Clonburris SDZ,
Dublin 22

Ronan Mac Diarmada & Associates

ADDITIONAL INFORMATION RESPONSE

November 2022

Infrastructure Works Impact Plan

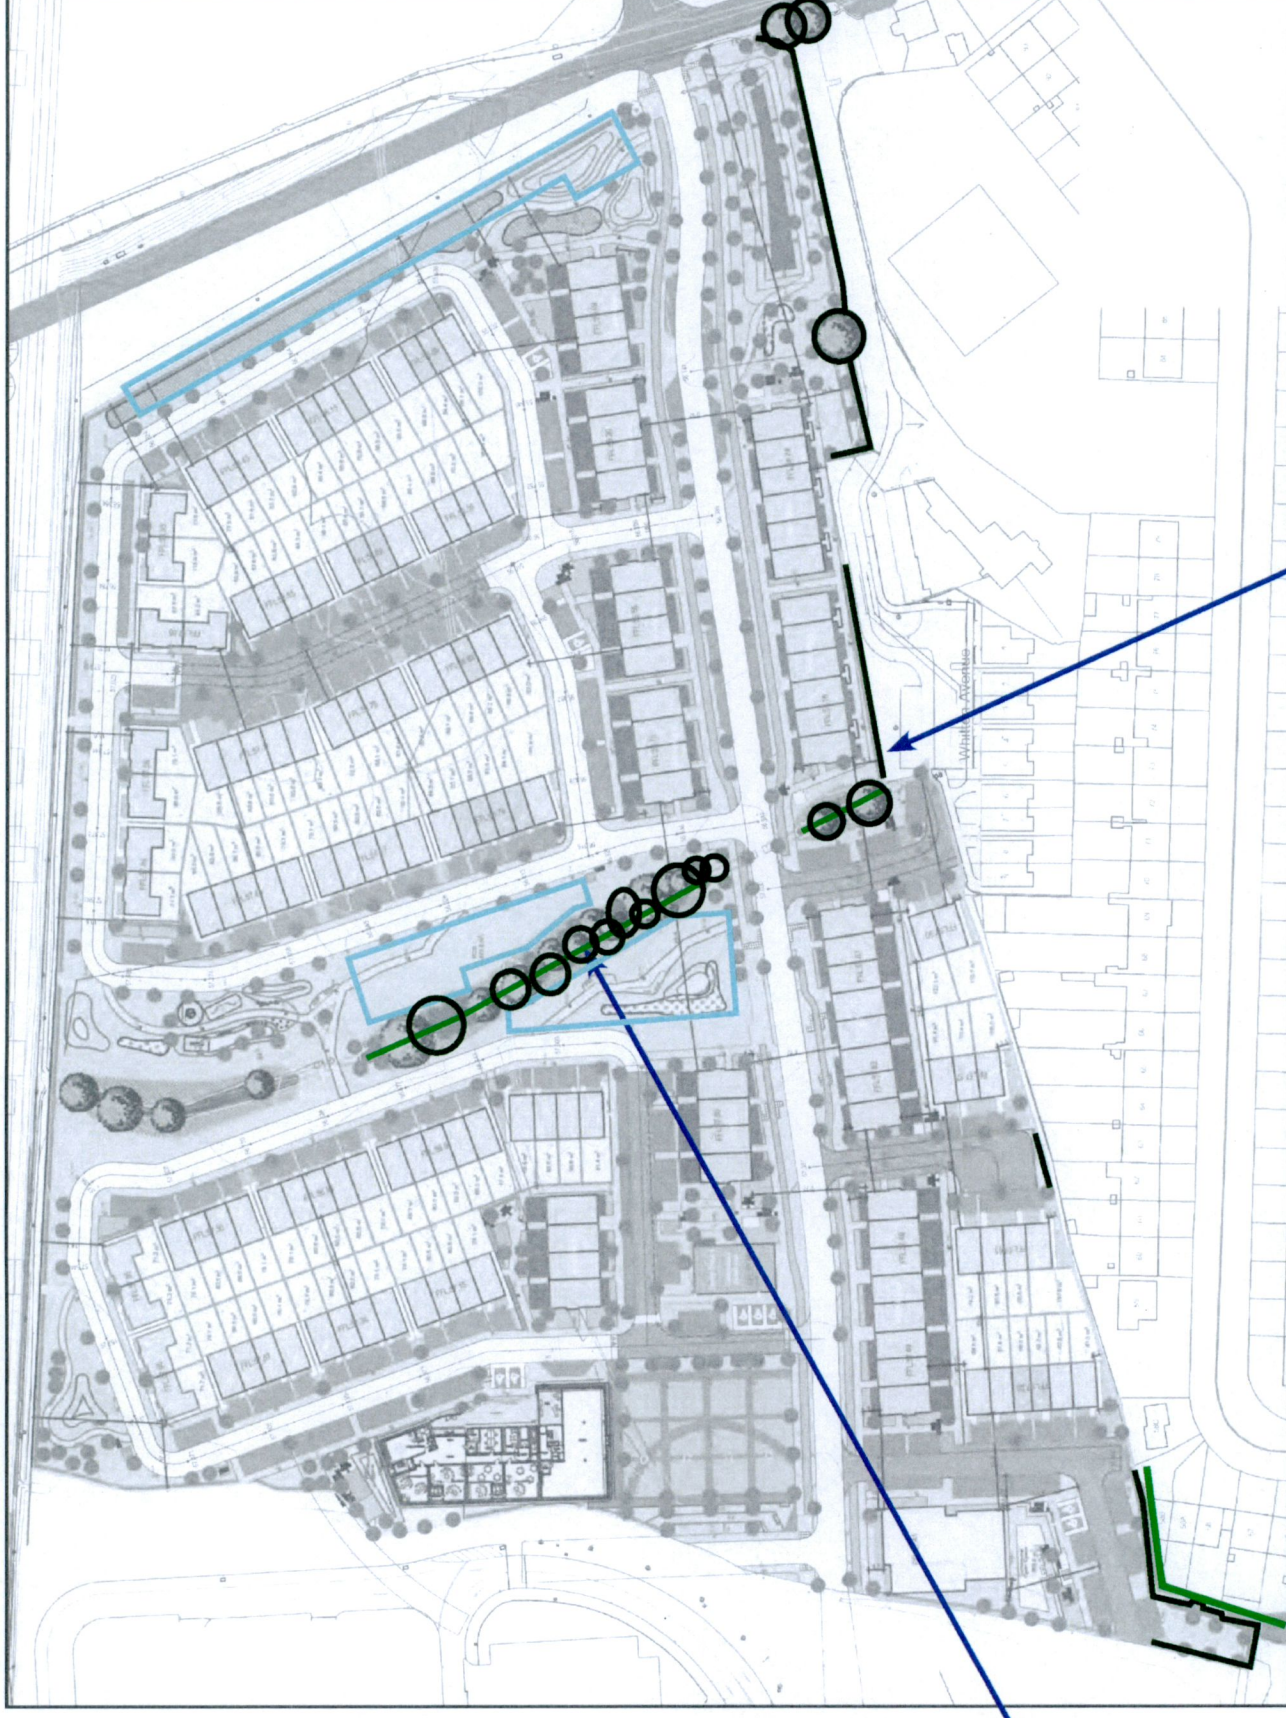
We note that The SDC Scheme states "Developments on the SDZ lands should identify and protect (where possible) the existing green infrastructure elements on the lands including green open spaces, hedgerows, large trees, watercourses and other natural physical features as these are a strong part of the lands history and will define the character of areas and help to create attractive neighbourhoods"

Therefore, we have identified the major north-south hedgerow, the existing hedgerow to the south will be altered due to infrastructure works, however we propose native hedge planting along all new boundaries where possible.

Pollinator species shall be planted to the private realm of house fronts and we propose the planting of native trees throughout all the open spaces and on streets.

The proposed trees shall exceed the number of trees currently located on the site. (351 trees to be planted throughout site)

To mitigate hedgerow loss along the southern boundary, we have proposed native hedge planting along the southern boundary where possible.

Boundary Treatment Plan

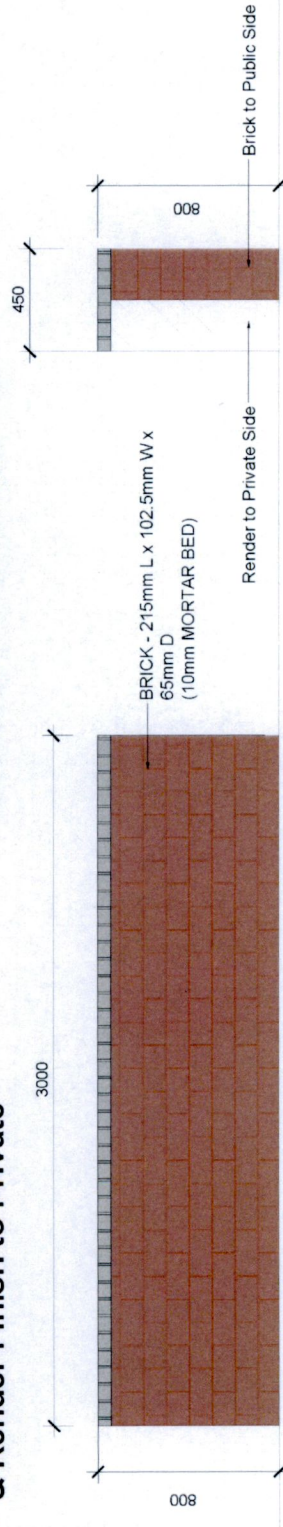
Boundary Treatment. The proposed boundary treatment includes 1.2m high parkland metal railing along the sides of corner sites. This is not acceptable and should be replaced with a low wall or similar.

The railings were proposed so pollinator hedges of passive supervision could be part of the design development of the site. We feel that the walls would be visually dominant on corners. We respectfully request that the local authority would review the provision of walls at corners within the site. Therefore we are looking for confirmation from SDCC on the detail on the boundary treatment in the corner location

Planting of Trees in Homezone & Wayleave Location Plan

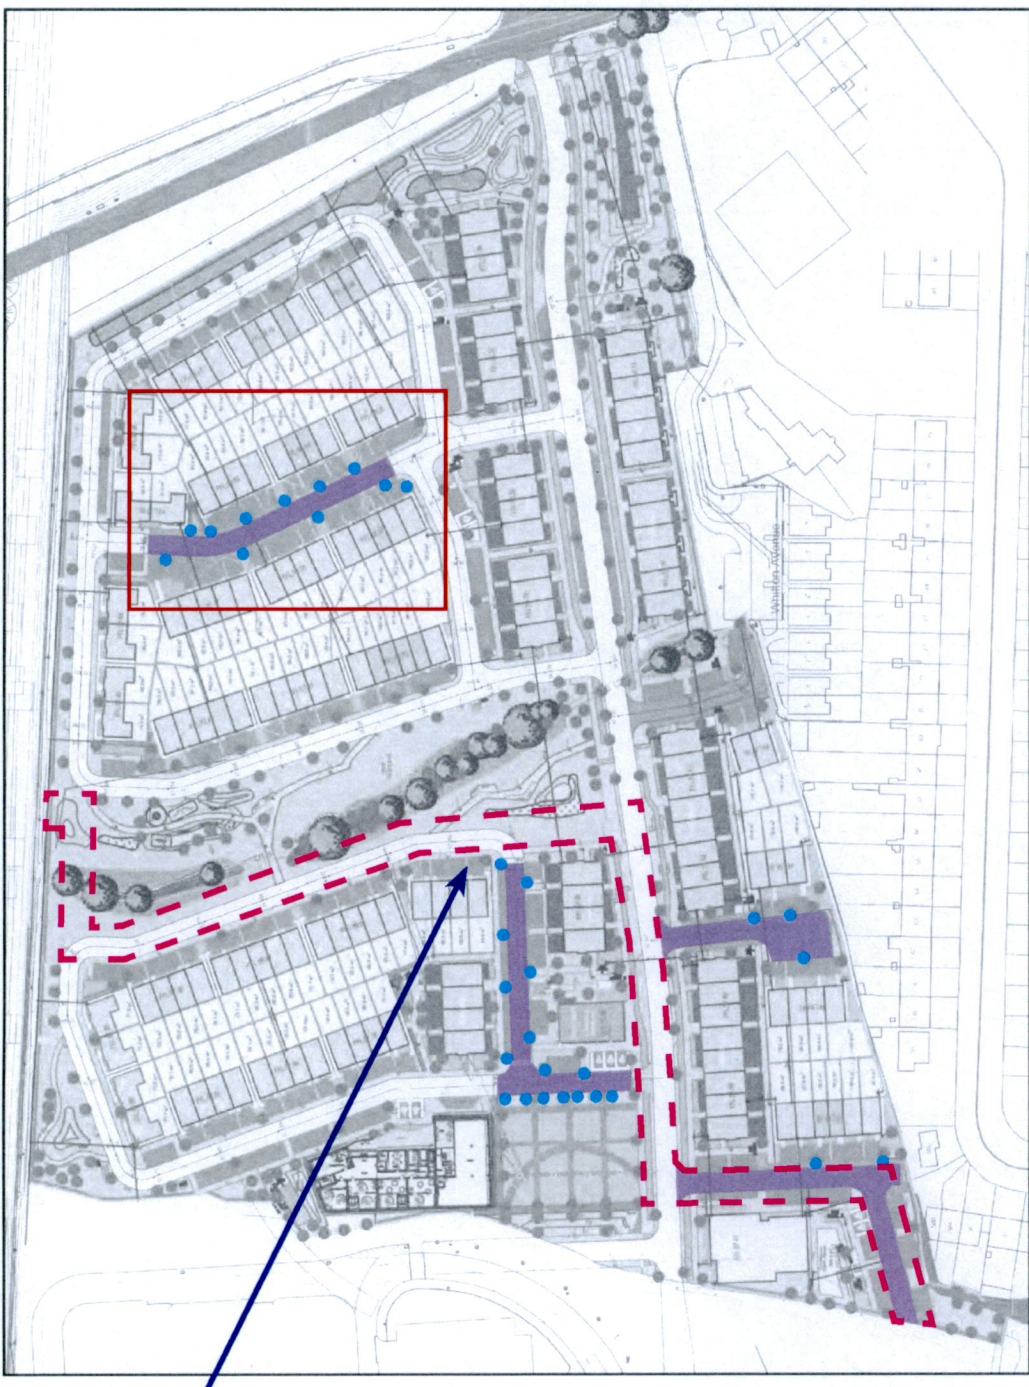
Green Infrastructure. A revised proposal that provides for the Strategic Green Corridor and Local Green Corridors as indicated in Figure 2.3.1 of the Planning Scheme. Street trees should be provided on both sides of local streets and homezones.

Street trees shall be provided as far as practical. It shall be coordinated between M&E, Civil Engineer and Service Engineer. A revised proposal has been developed to provide for native hedge & tree planting for the Strategic Green Corridor (SGC) & LGC.. Fig 2.3.1

Street trees shall be provided on both sides of local streets & homezones. Note, that there can be no tree planting within the wayleave exclusion zone.

Homezone Location Plan

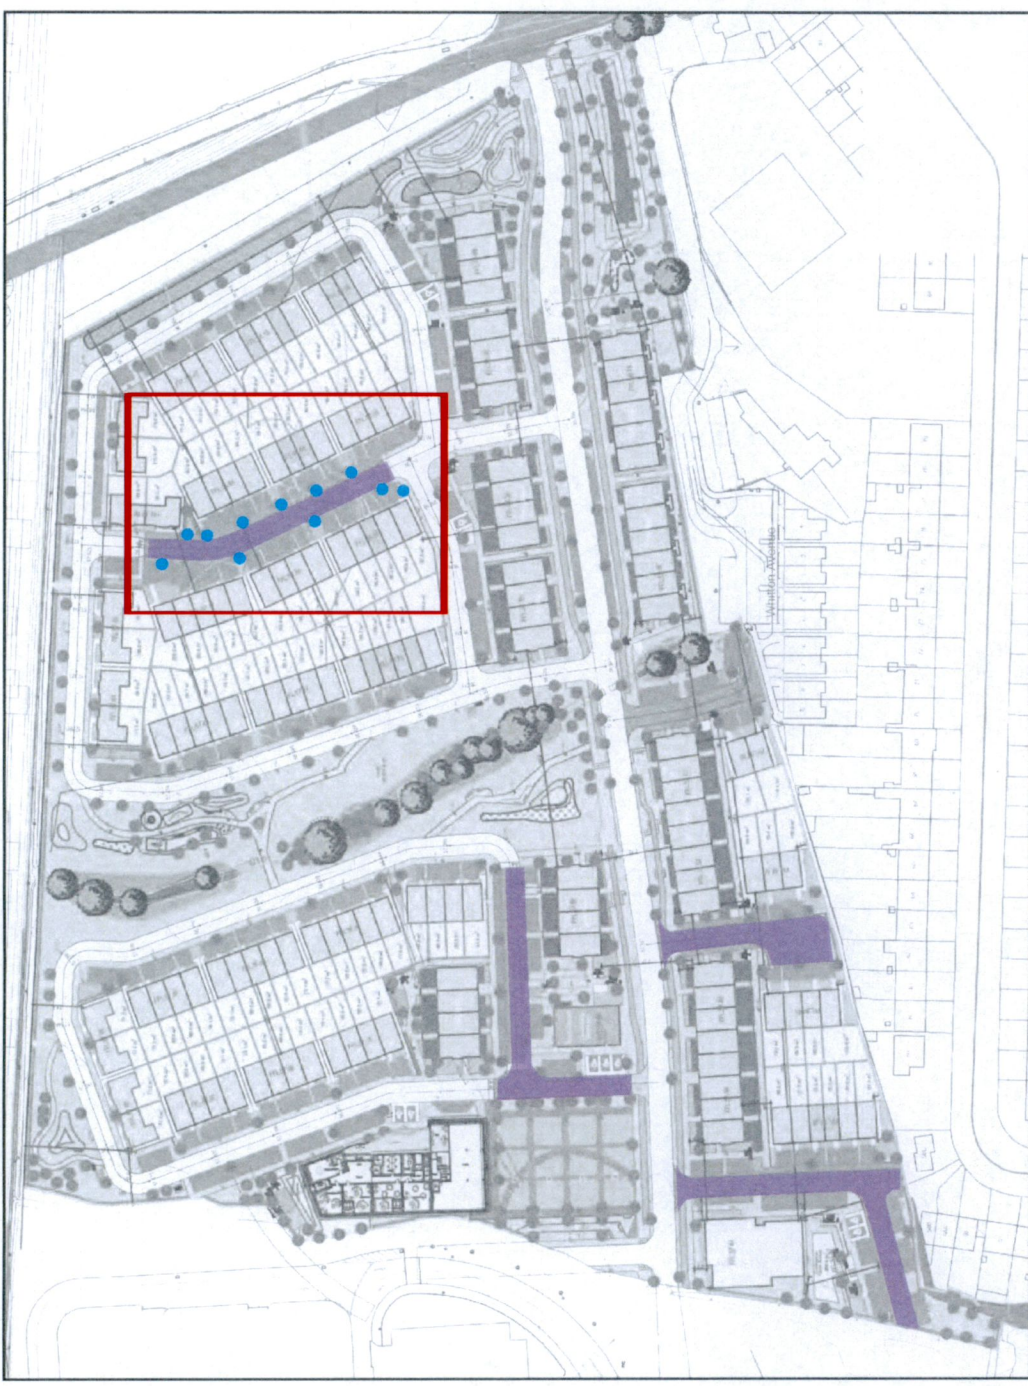
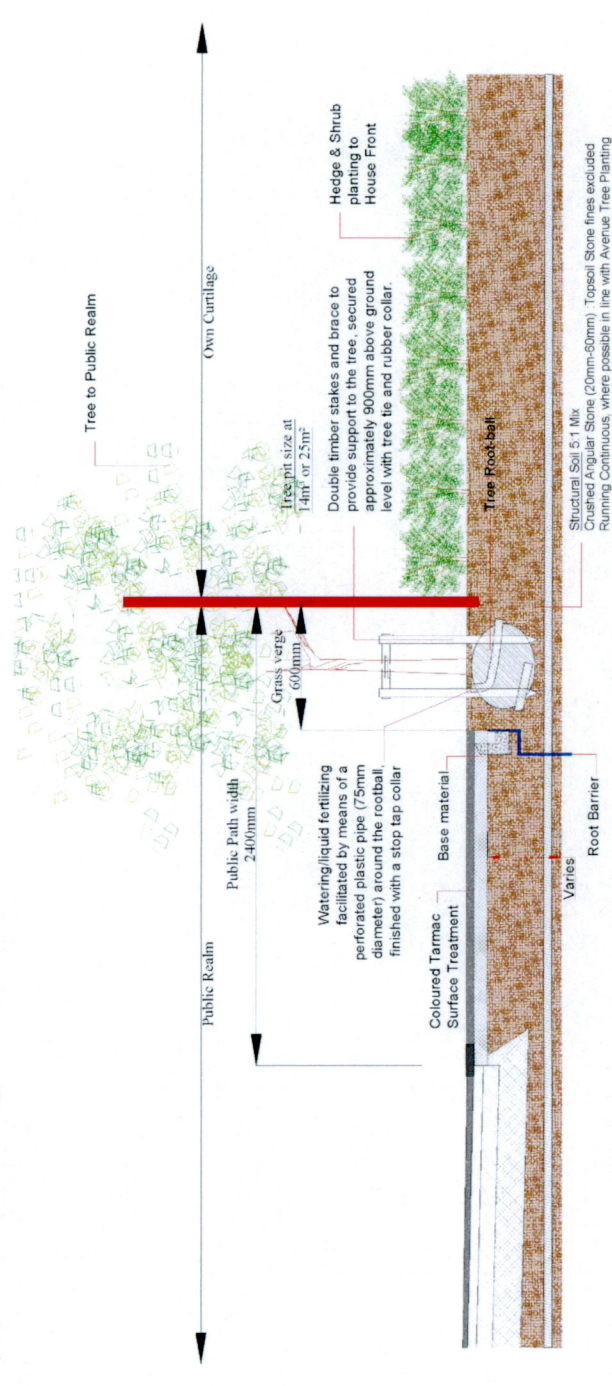
Green Infrastructure. A revised proposal that provides for the Strategic Green Corridor and Local Green Corridors as indicated in Figure 2.3.1 of the Planning Scheme. Street trees should be provided on both sides of local streets and homezones.

Trees shall be provided as far as practical. It shall be coordinated between M&E, Civil Engineer and Service Engineer.

Note services require 1500mm of space, the tree pit have to be provided into the private realm.

Retained & Removed Hedgerows & Trees Plan

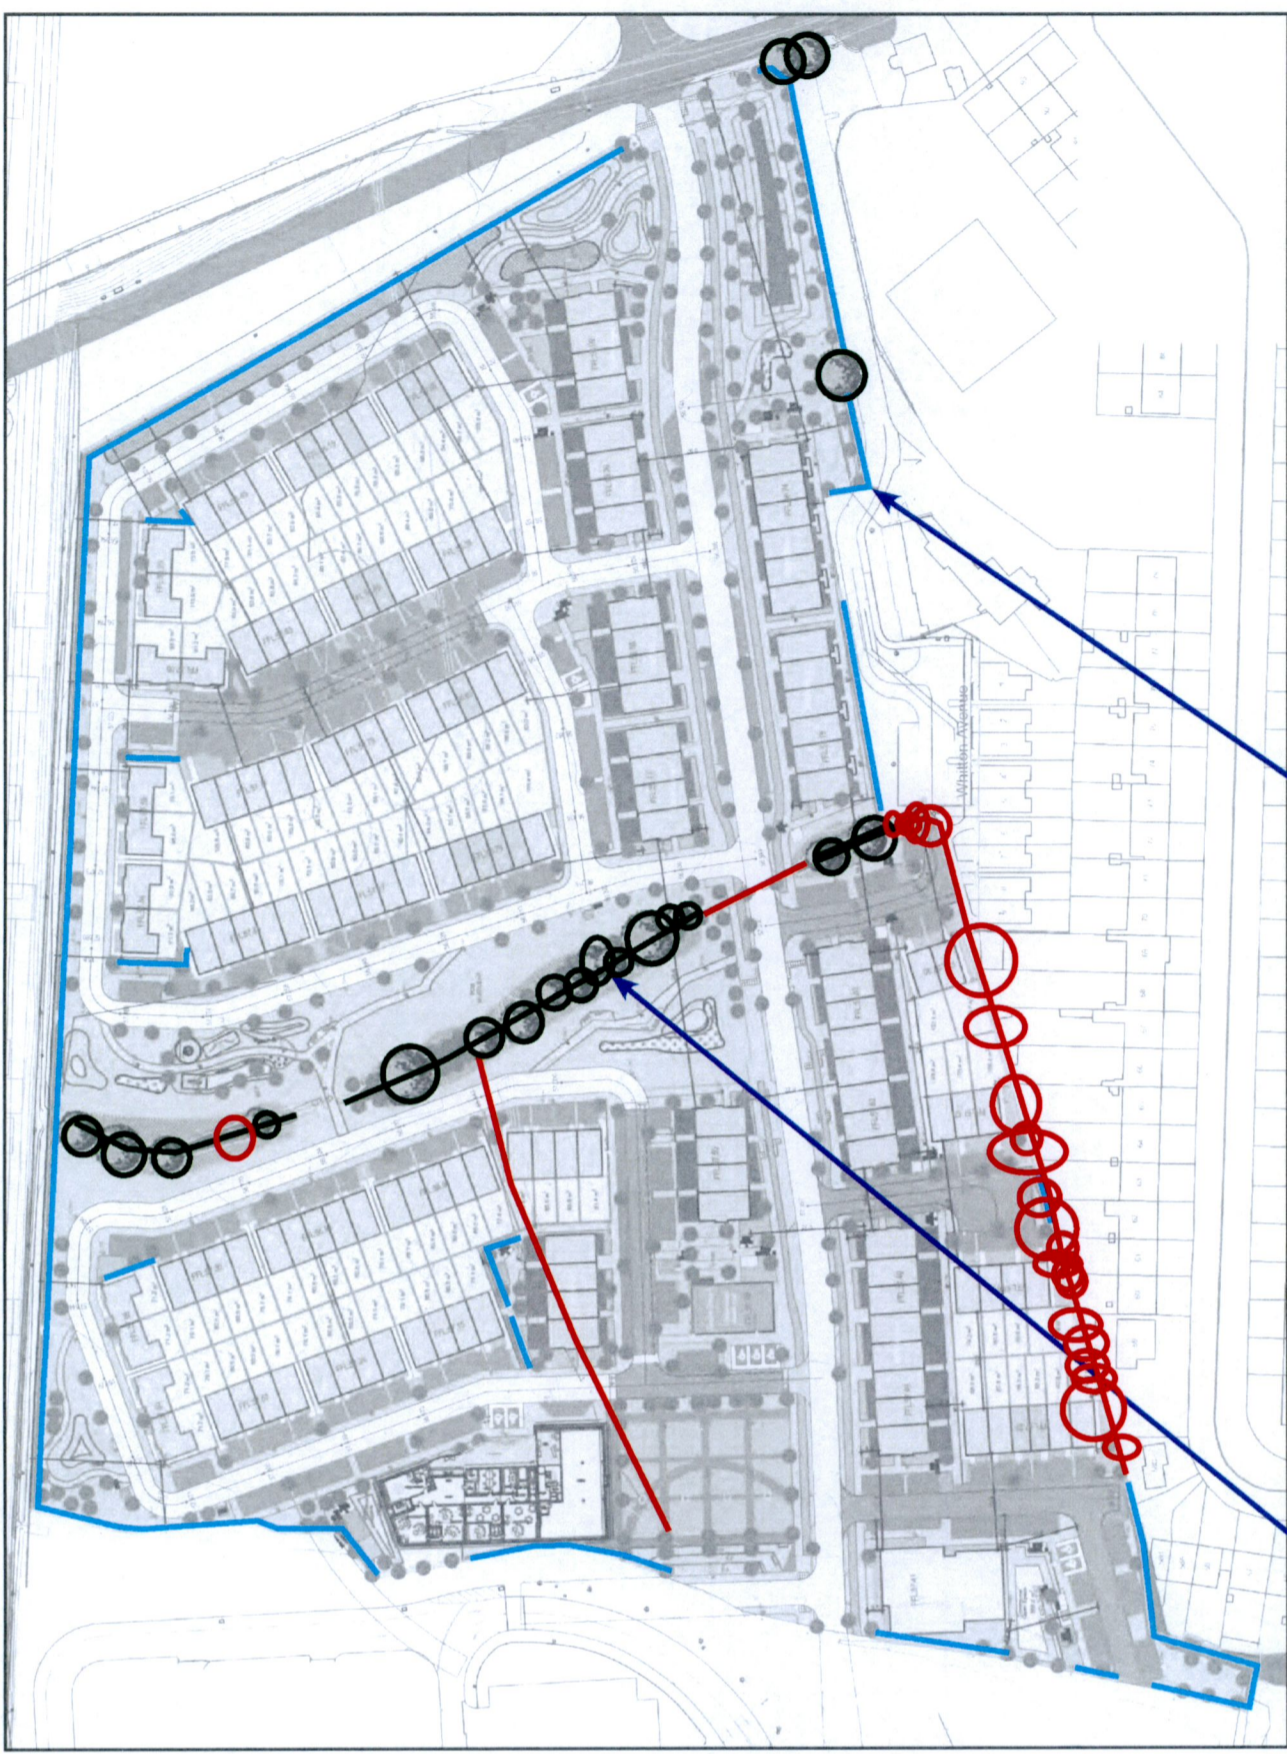
A tree and hedgerow management plan that shows the amount of trees and hedgerow being removed and the amount of compensatory/replacement trees and hedgerow being planted as part of the proposals. To be in compliance with the SDZ and the requirement of no net loss of hedgerow across the scheme, the amount of compensatory/replacement hedgerow provided in this development shall be at least equal to that being removed. A bond will be required for all trees and hedgerows to be retained by the Planning Scheme

Trees and hedgerows are to be retained where possible. Any removed vegetation will be replanted with Native species.

The amount of trees of compensatory/replacement hedgerow provided in the development are greater than trees to be removed. Therefore, there is no net loss of hedgerows provided in the development.
